UNITED STATES PATENT AND TRADEMARK OFFICE

APPLICATION NO.	FILING DATE	FIRST NAMED INVENTOR	ATTORNEY DOCKET NO.	CONFIRMATION NO.
10/511,071	10/12/2004	Steven Victor Jones	BR8812	7044

Office Action Summary	Application No.	Applicant(s)	
	10/511,071	JONES	
	Examiner	Art Unit	
	Katherine W. Mitchell	3677

DETAILED ACTION

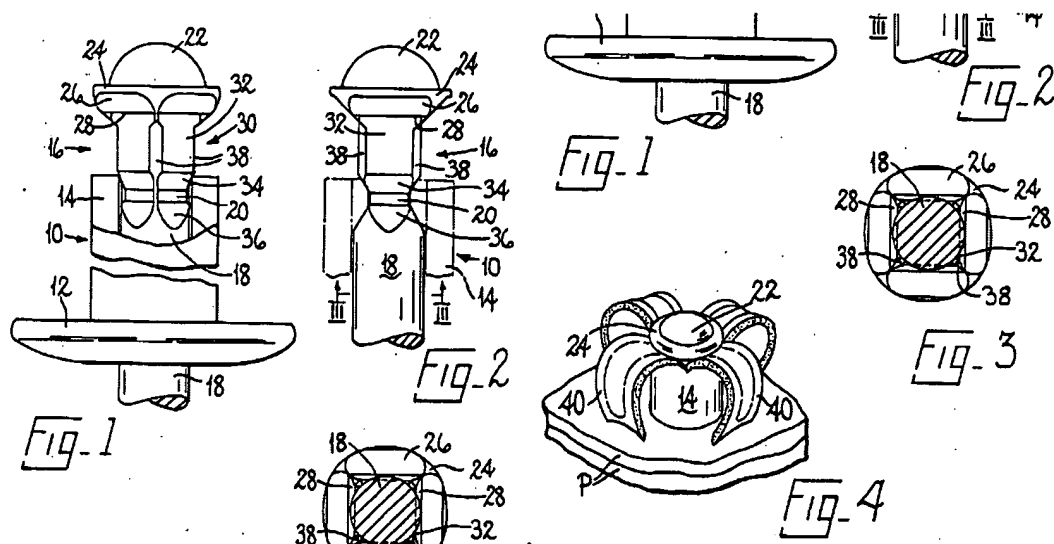
Re claims 1-2: Potzas in Figs 1-4 (above) teaches Potzas teaches a peel type blind rivet (abstract) settable in soft material, having an elongate body 10 with a shank and preformed head 12 at one end, and a plurality of slots 12 terminating at the end remote from the head. There is a mandrel (16, column 2 lines 49-50) having a stem (18) which extends through coaxial with said body and having an enlarged head (22) with a maximum external diameter greater than the internal body diameter (Figs above). The mandrel head forms a shoulder between the mandrel stem and an outer surface of the head, -- the deforming means (head) presents a substantially flat surface perpendicular to an axis of said mandrel, in that the underside of head 22 terminates in plane forming flat shoulders 28 normal to axis of stem, which as shown in Figs 1- 4 and discussed in column 2 lines 62-68 is described as "flat shoulders 28 normal to the axis of the mandrel".
